TECHNICAL SERVICE BULLETIN

No. 988410-002
Machine:8410
System:Engine Gas/LP

LRG 2.3L DIS ENGINE PERFORMANCE PROBLEM

Fig. 1

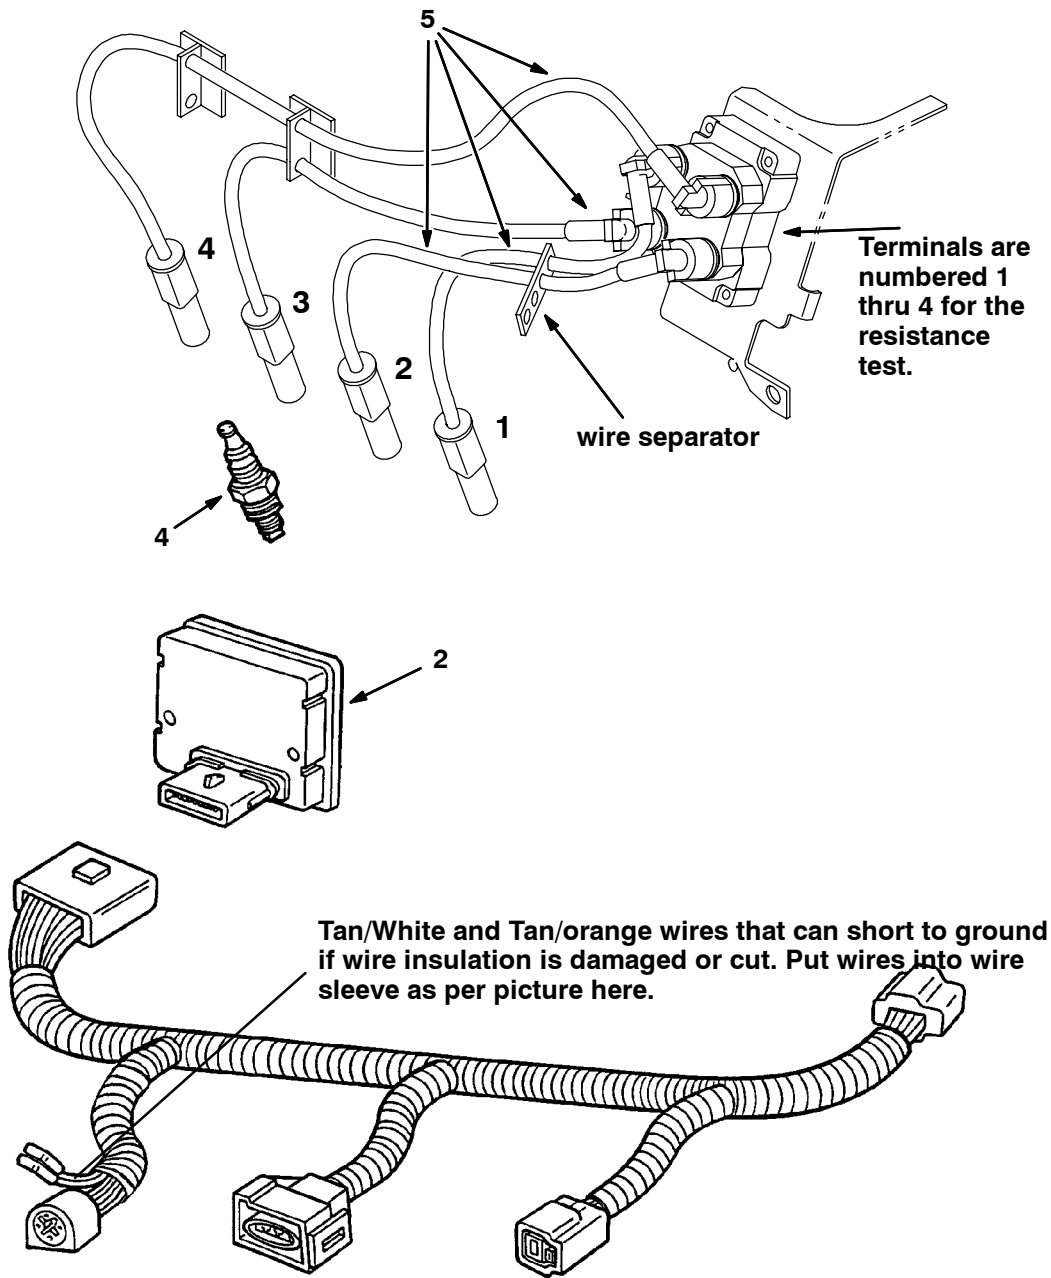
1. The tan/orange wire or the tan/white wires that go from the engine spark control unit to the coil pack have rubbed against a sharp edge on the engine block and allowed the wires to short to ground.

2. If the spark plug wires are touching the upper radiator tube they may arc to each other over time and rubbing will cause the coil pack to fail.

1. In regards to cause number 1 above: Tie the wires away from the engine cover or put the wires in the wire harness sleeve and replace the coil pack if needed. New machines in production now have the wires protected by the wire harness sleeve.

2. In regards to cause number 2 above: Ford engineering has advised to make sure the spark plug wires are kept away from the upper radiator tube (see attached page for wire routing) and that a wire separator is used to keep plug wires away from each other. If you need a plug wire separator order part number 84882 .
